802.3dj D2.0

Comment Resolution

Common Track

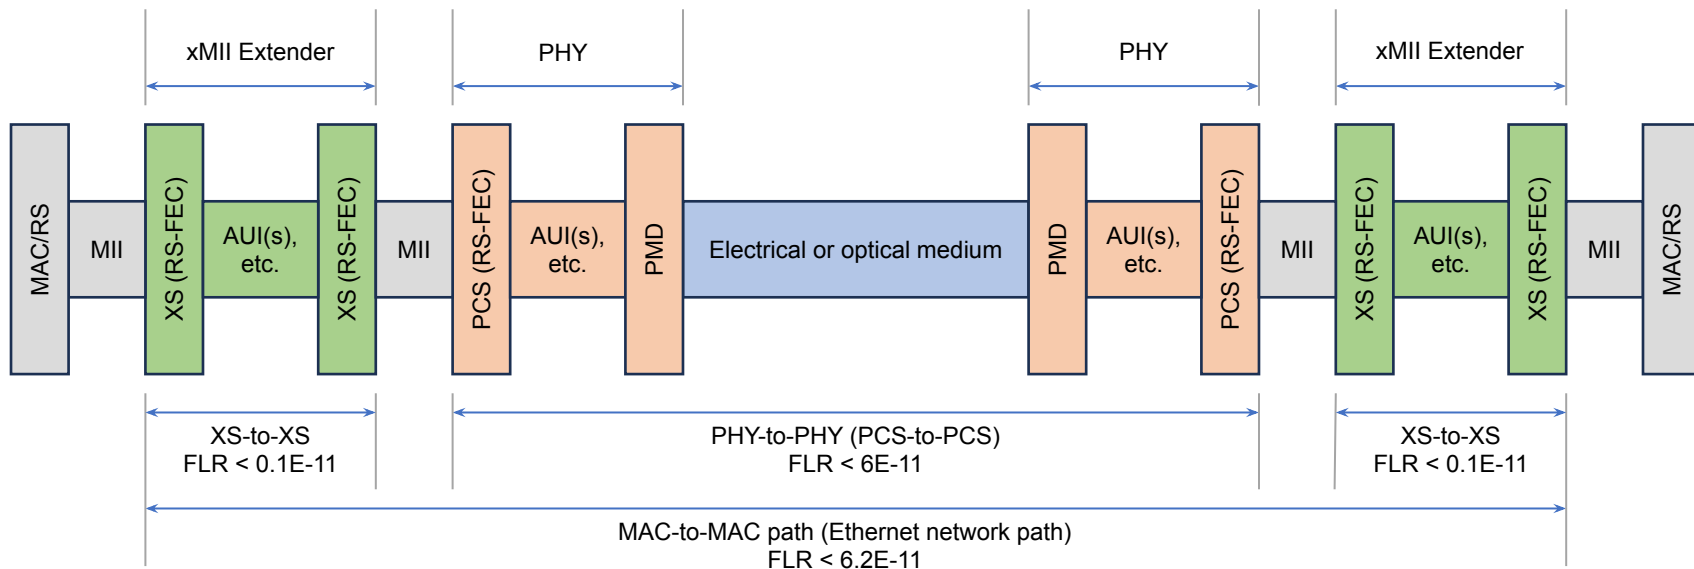
#292 and #106 propose adding figures to help understand the context for each of the error ratio allocations.

Note also, that #590 (in bucket #1) proposes to rename “network path” to “mac-to-mac path”.

PROPOSED ACCEPT IN PRINCIPLE.
Ultimate the path is from MAC to MAC. Also, RS can easily be misinterpreted as meaning RS-FEC.
Change "network path" to MAC-to-MAC path.

Option #2: Allow either AUIs in the PHY or Extender, but not both

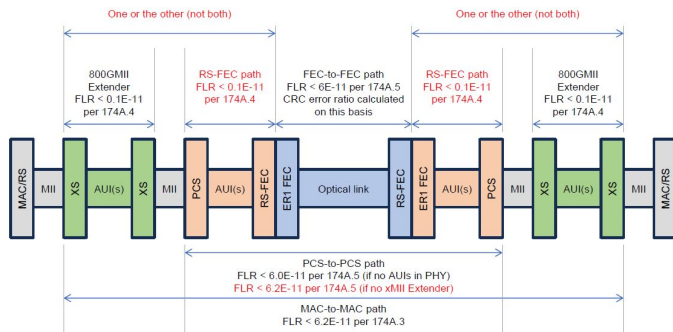
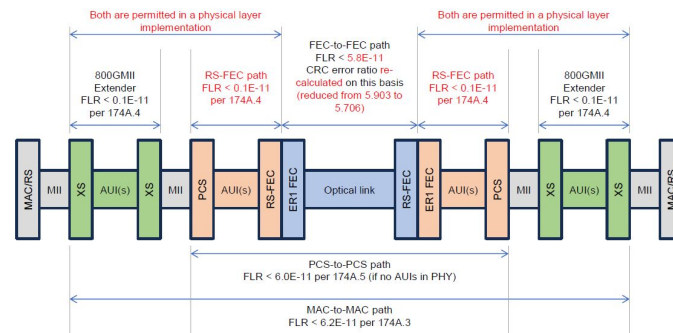
For 800GBASE-ER1/ER1-20...

Option #2 (above) was adopted in Draft 1.5.

- Requires different figure

D2.0 comment #xxx proposes to adopt option # (right)

- Can use same figure as previous slide, if adopted

Proposed figure for optical PHY types

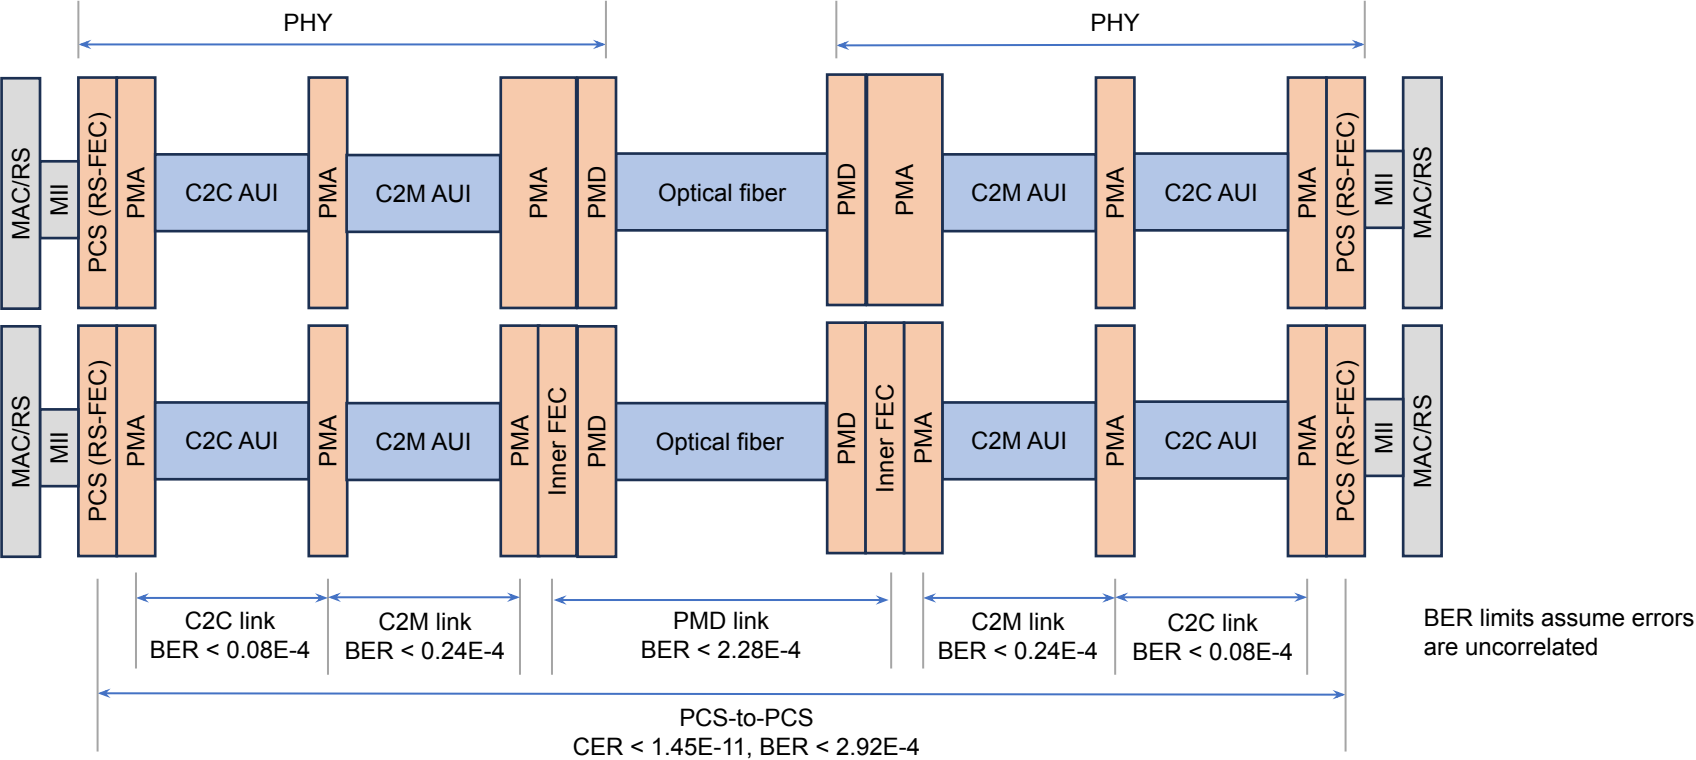
Diagrams showing the various paths or domains described in 174A.3 through 174A.7 would be very helpful to the reader of the annex.

A figure will make this much more clear

Comment #585 proposes to change the FLR budgeting for 800GBASE-LR1. The appropriate diagram can be used once that decision is made. Shown here for reference.

Add a diagrams illustrating the paths described in 174A.3 through 174A.7.

Add a figure to show the link in 174A.5, 174A.6 and 174A.7

Figure 178B-8—Training control state diagram

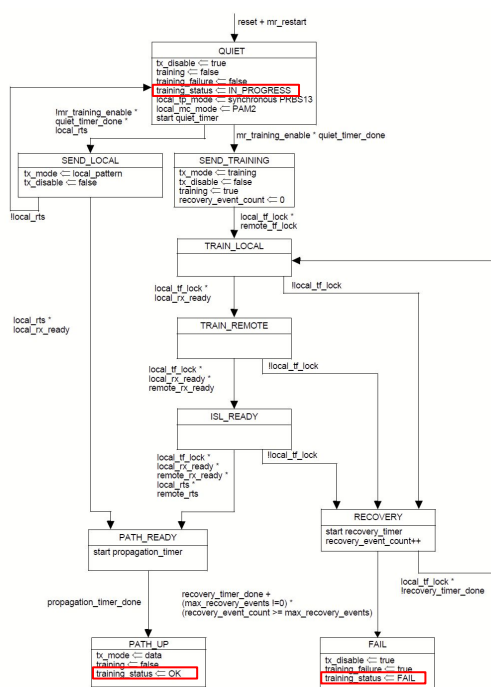
The variable training_status is used by the 'Training control state diagram' in subclause 178B.14.3.5 'State diagram figures' but is not defined in the associated subclause 178B.14.3.1 'Variables'.

In addition, it appears that the training_status is a per-interface variable based on the definition found in 178B.14.2.1 'Variables', yet it appears to be driven by both the per-interface 'RTS update state diagram' (Figure 178B-7) and the per-lane 'Training control state diagram' (Figure 178B-8). I'm not sure how this would operate.

As an example, if the Training control state diagram on one lane in an interface enters the FAIL state, it would set training_status for the interface to FAIL. If, however, the Training control state diagram on another lane in the same interface enters the PATH_UP state immediately afterwards, training_status for the interface would then be set to OK. This doesn't seem to be correct.

training_status is defined as a per-interface variable (in 178B.14.2.1), but it appears in both per-lane and per-interface state diagrams. Formally there needs to be more than one variable.

Define a new variable in 178B.14.3.1 (Per-lane variables): lane_training_status

Use this new variable in the per-lane state diagrams instead of training_status.

Option B: delete its assignment from the per-interface state diagram (Figure 178B-8), making it a non-state-diagram variable, and use the following definition:

Figure 178B-7—RTS update state diagram

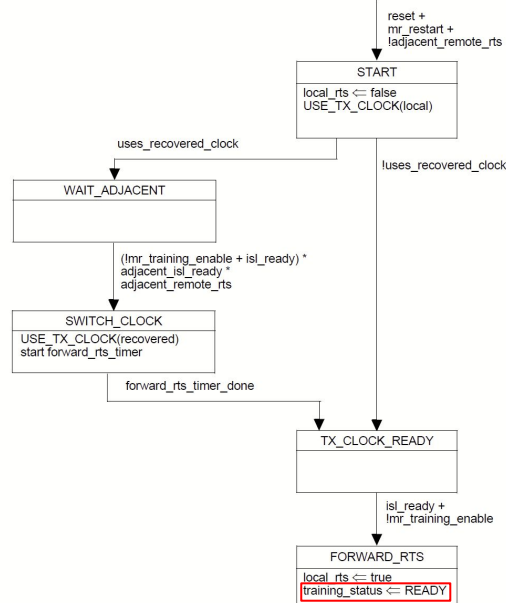
Training status can not be both a AUI component variable and a per-lane training variable.
Local_rts is an equivalent status to it and is mapped to a MDIO register bit.

Note that the value READY is assigned only be the per-interface state diagram; READY is equivalent to (all lanes are IN_PROGRESS) and (local_rts is true).

Move the definition of training_status to 178B.14.3.1
Remove the enumeration of "READY" from its definition.
Delete training_status <= READY from Figure 178B-7

Option A: keep it as a state diagram variable and change its definition as follows:

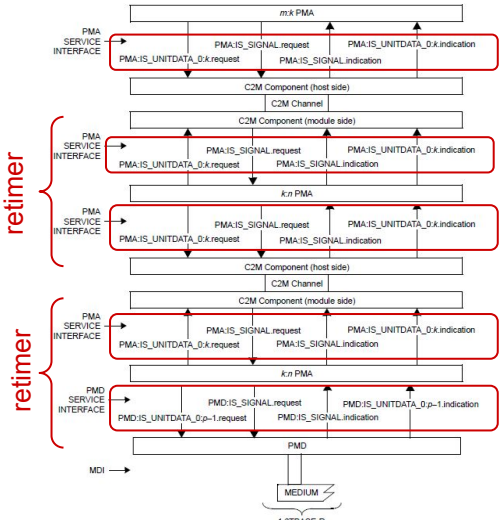
This is not very clear. I would suggest adding the definition of "adjacent service interface" in subclause 178B.3.

The second case in the NOTE says: "For ILT in an AUI component above a PMA, the adjacent service interface is the interface below the AUI component". That is the PMA's service interface. It may be easier to understand if it is stated.
 Also, a figure illustrating the two cases would be helpful.

There is only one service interface on an AUI component or PMD, so it is not necessary to qualify it with the word "adjacent".

In fact, the word adjacent is used to reference the AUI component or PMD on the other side of a retimer.

Change the note in 178B.14.2.1 to:

NOTE — For a PMD or an AUI component below a PMA, SIGNAL_OK is received via the IS_SIGNAL.request primitive of the service interface above the PMD or AUI component. For an AUI component above a PMA, the SIGNAL_OK is received via the IS_SIGNAL.indication primitive of the service interface below the AUI component.

Change other references of "adjacent service interface" to "service interface".

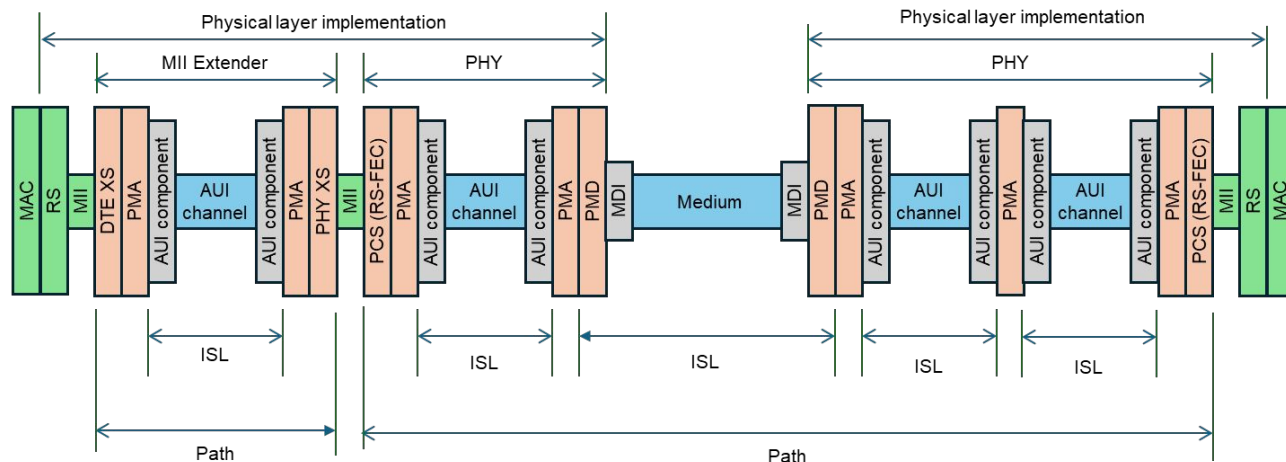
Given the introduction of inter-sublayer link training to the Ethernet world, it would be helpful if the term inter-sublayer link (ISL) was displayed graphically for the reader.

This diagram is provided as a reference for discussion and as a proposed diagram to add into Annex 178B.

As shown, the diagram includes two path types: XS-to-XS in an xMII extender and PCS-to-PCS across a pair of PHYs and the medium between.

Implement figure on Page 3 of
https://www.ieee802.org/3/dj/public/adhoc/electrical/25_0605/dambrosia_3dj_elec_02_250605.pdf with editorial license

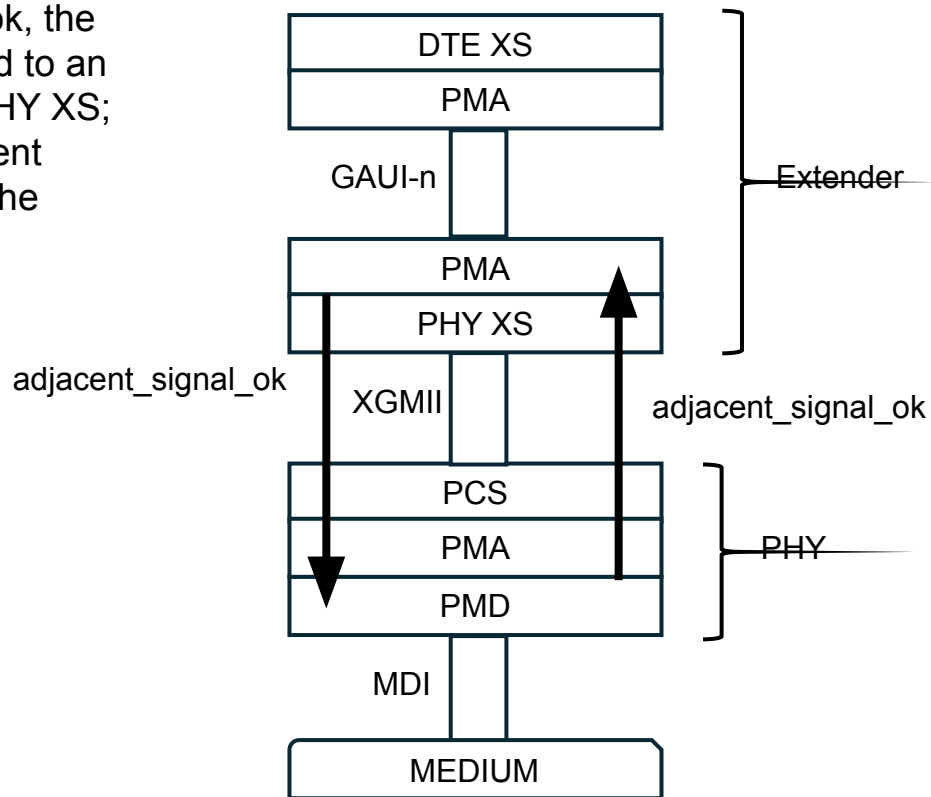
The text about training xMII extenders does not address the communication of the status variables `isl_ready` and `remote_rts` between interfaces (PMD to AUI and vice versa) when there is a PHY XS and PCS between them.

Ideally, this communication should be the same as the one defined in 178B.14.2.1 using `adjacent_signal_ok`, but the case of an extender is not covered by NOTE that describes what "adjacent" is.

Since this behavior is specific to PHYs attached to extenders, it should be specified in this subclause, preferably with a diagram.

Add a NOTE in 178B.5.3 stating that, for the purpose of `adjacent_signal_ok`, the adjacent interface of a PMD in a PHY attached to an xMII extender is the service interface of the PHY XS; and the adjacent interface of the AUI component above the PHY XS is the service interface of the PMD.

Add a figure to illustrate the communication of `adjacent_signal_ok` between the PMD and the AUI (across the PCS and PHY XS, and possibly other sublayers).

NOTE – For the purpose of adjacent_signal_ok, the adjacent interface of a PMD in a PHY attached to an xMII extender is the service interface of the PHY XS; and the adjacent interface of the AUl component above the PHY XS is the service interface of the PMD.
